Product Change Notification

PCN No: 2009-11-10-02

Subject: MOP-AV202C-BNNN and VK202-25

New Screen Board Revision Release

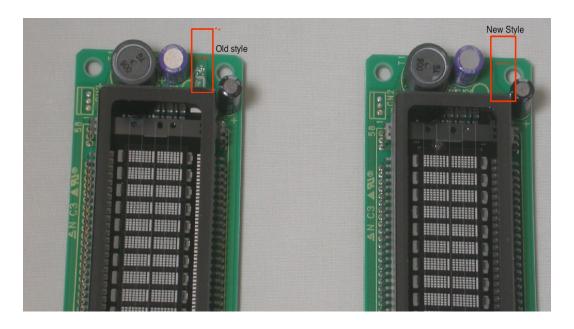
Our vacuum fluorescent display manufacturer has updated the 2x20 VFD displays with a new piece of glass using tipless technology.

The vacuum fluorescent display remains almost exactly the same; the only change is the absence of the tip on the right side of the glass. The change is so minor that the manufacturer has not changed the internal part number for Matrix Orbital.

December 2009, as stock permits.

Old style stock is to be depleted before the new style is used.
